**Certified Action** of the City of Raleigh Planning Commission City of Raleigh Development Plans Review Center One Exchange Plaza Raleigh, NC 27601 (919) 516-2626 www.raleighnc.gov

Case File / Name:	SP-5-09 / The Park at Lake Boone
General Location:	On the north side of Lake Boone Trail between its western terminus and Lake Drive just west of Blue Ridge Road
Planning District / CAC:	Northwest / Northwest
Nature of Case:	A three story 26,196 square foot office building on a 2.44 acre tract zoned Office and Institutional-1 Conditional Use District. As this office use exceeds 25,000 square feet and is within 400 feet of a residential use or zone, Planning Commission approval is required.
Key Issues:	As presented, staff finds that this plan conforms to Code standards and adopted land use policies.

SUBJECT:	SP-5-09 / The Park at Lake Boone				
CROSS- REFERENCE:	Z-88-94				
LOCATION:	This site is located on the north side of Lake Boone Trail between its western terminus and Lake Drive just west of Blue Ridge Road, inside the City Limits.				
REQUEST:	The proposed development consists of a three story 26,196 square foot office building on a 2.44 acre tract zoned Office and Institutiona

SP-5-09 / The Park at Lake Boone – Preliminary Site Plan

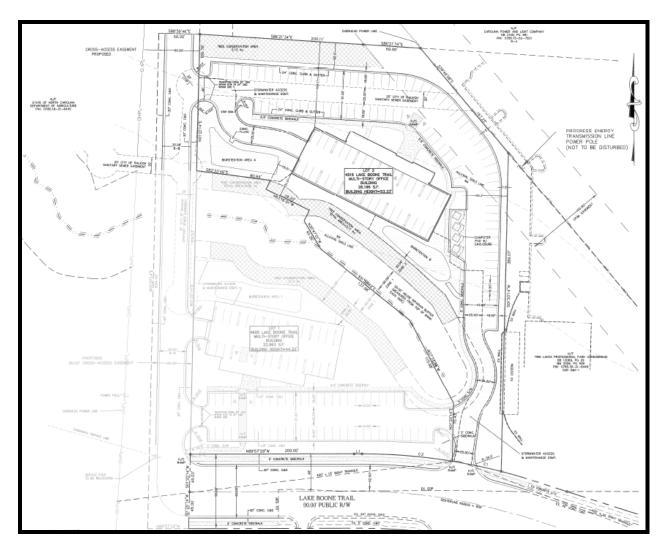
- (5) That the plans be revised to ensure the grading for the bio-retention area B does not conflict with the proposed sidewalk and landscaping adjacent to the refuse collection enclosure;

(6) That the location of the proposed sewer line and easement to serve the lot to the east be revised and approved by the Public Utilities department;
